August 1, 2006

RE: **Variance Approval**
14661 Red Lion Dr.

LOT 16
RED LION INN ESTATES
 (A RESUBDIVISION OF LOTS 7 & 8,
 RED LION INN ESTATES, PLAT #5027)
 4TH ELECTION DIST. HOWARD CO., MD.
 SCALE: 1"=100' JULY 13, 2006

PROPOSED CARPORT

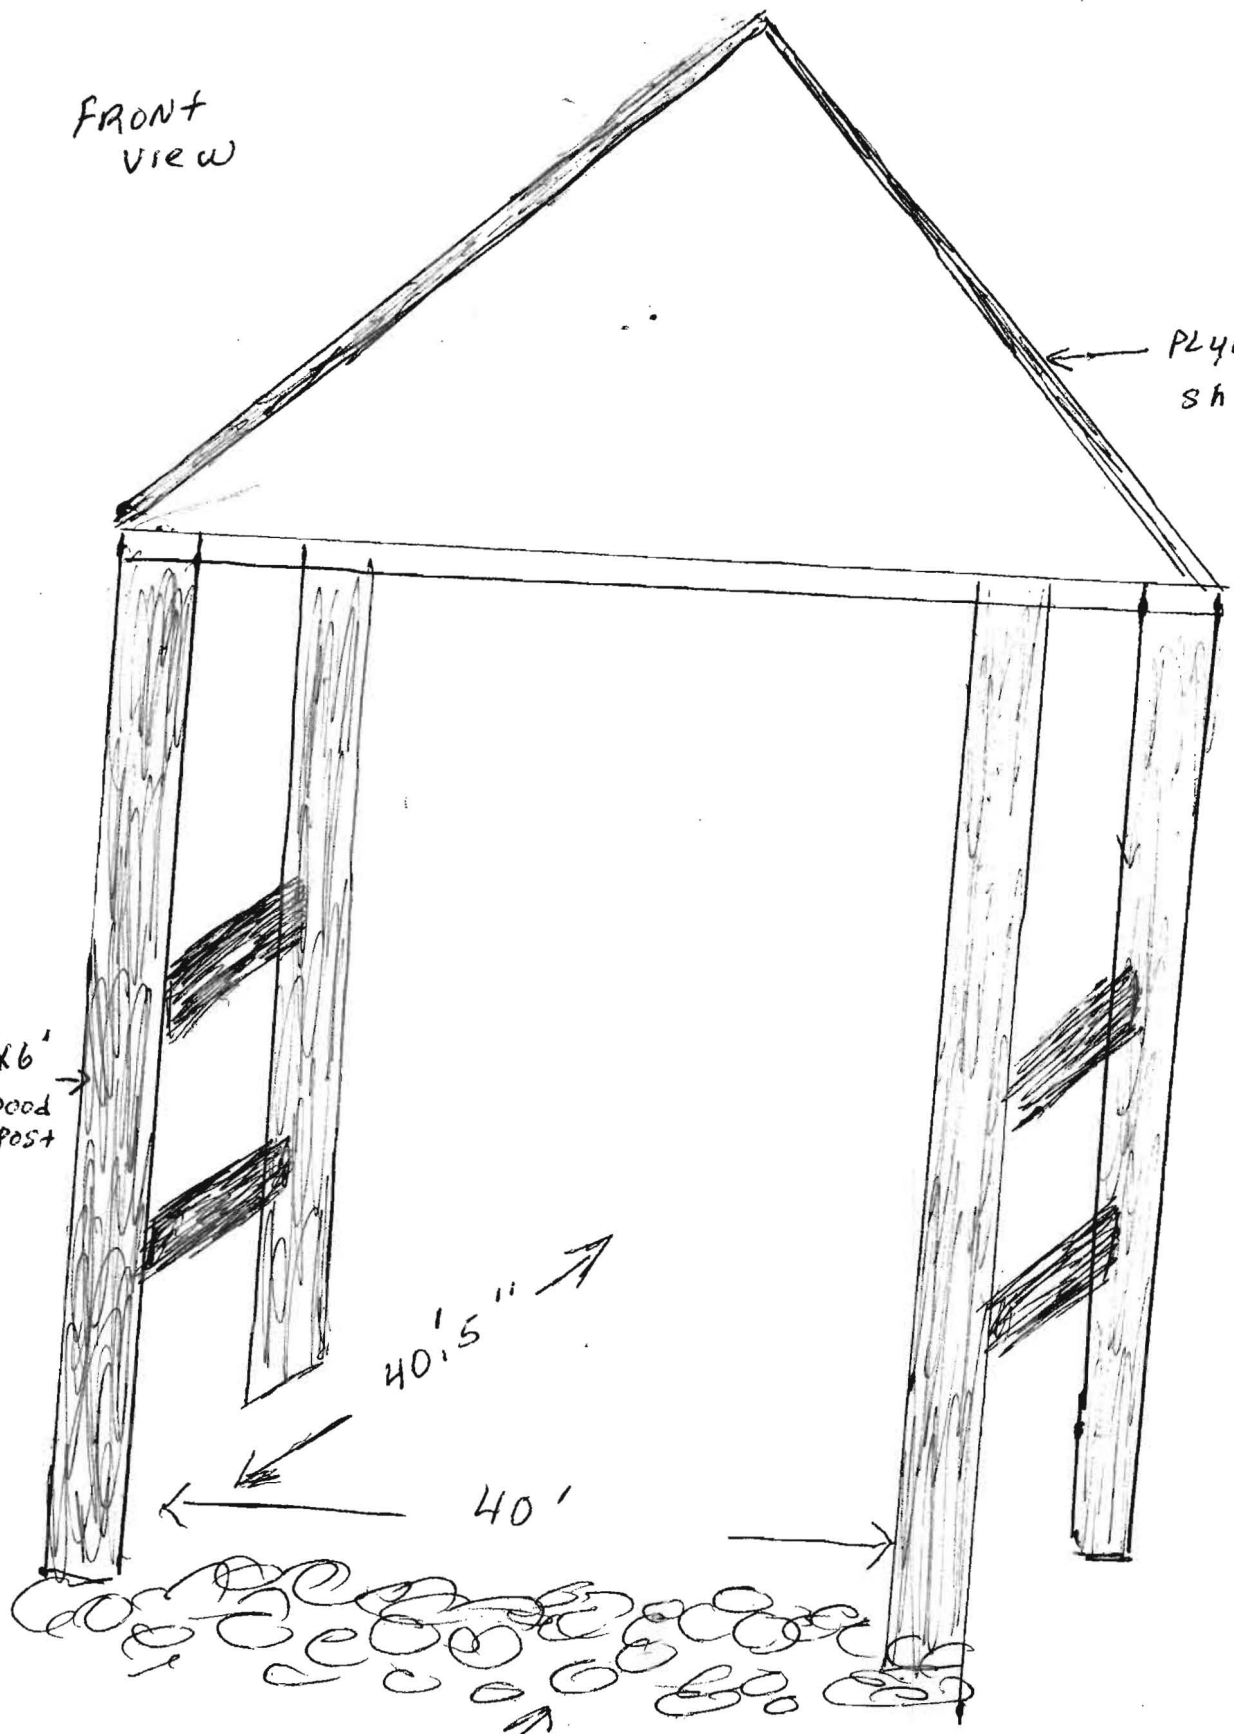
I'm WRITTING TO YOU SIR FOR A VARIANCE FROM
THE STANDARD 30' SETBACK TO WELLS FROM A GARAGE
DUE TO REASONS STATED:

- ① The PROPOSED CARPORT STRUCTURE IS NOT A
GARAGE, NO WALLS ONLY A ROOF AND FOUR WOOD
POST SUPPORTING ROOF, ^{OR MORE} COMPLETELY DETACHED FROM
THE EXISTING HOUSE, AND WOULD LIKE TO BE
APPROXIMATELY 10' FEET FROM THE EXISTING
WELL.
- ② The STRUCTURE WILL NOT HAVE A FOUNDATION, IT
WILL USE GRAVEL FOR THE FLOOR SURFACE.
- ③ The WELL IS UPHILL.
- ④ CONSTRUCTION OF THIS ^{PROPOSED} CARPORT WILL BE
IN WOOD AND SHINGLE ROOFING. (6'X6' ^{TREATED} LUMBER
4 POST-SUPPORT) ^{OR MORE}
PLYWOOD ROOF COVERED WITH SHINGLES.
- ⑤ The DIMENSIONS OF THIS CARPORT WILL BE
40' FEET WIDE AND 40' 5" FEET DEEP. AND BETWEEN 10' TO
12' HIGH.

The Department of Health received your variance request on July 14, 2006 for the above referenced property. This agency will grant **approval** of the variance provided that the carport is constructed no closer than ten (10) feet to the existing well. Approval of a building permit will be granted by this Department provided that the site plan submitted with the building permit application is consistent with the site plan approved under this variance request and the construction plans illustrate the construction of a forty (40) foot by forty (40) foot six (6) inch garage. Any deviations from the site plan submitted with the request will be subject to further review by this Department.

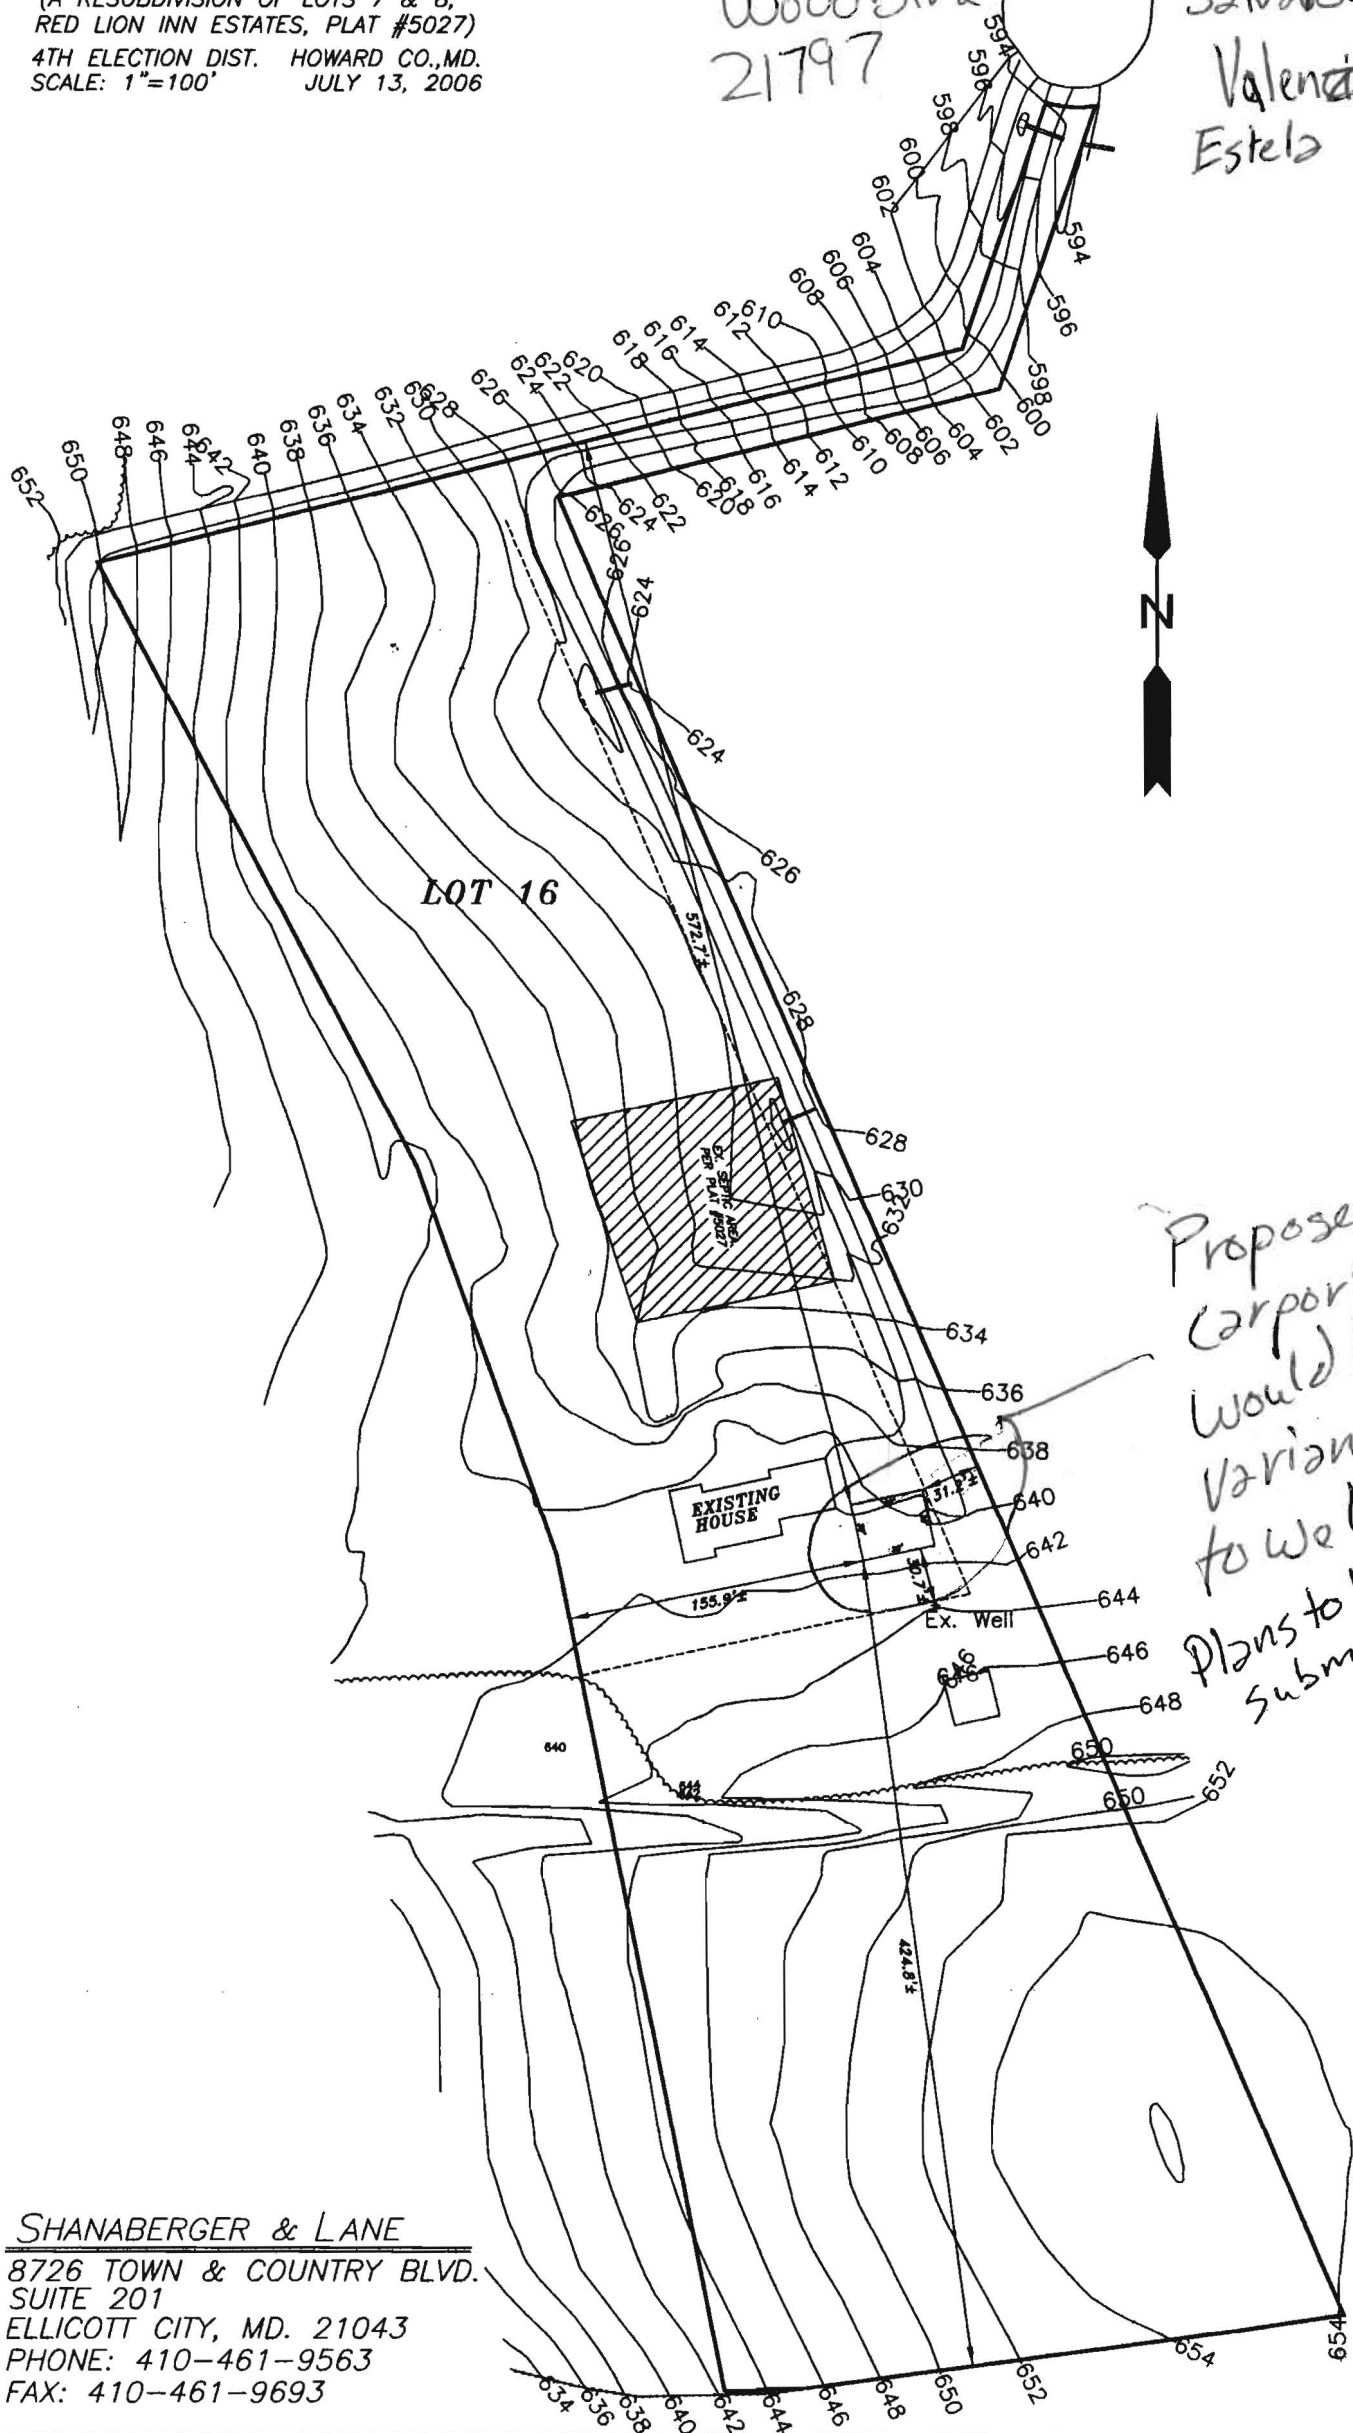
Proposed
 Carport
 Would like
 Variance
 to well (10')
 Plans to be
 submitted
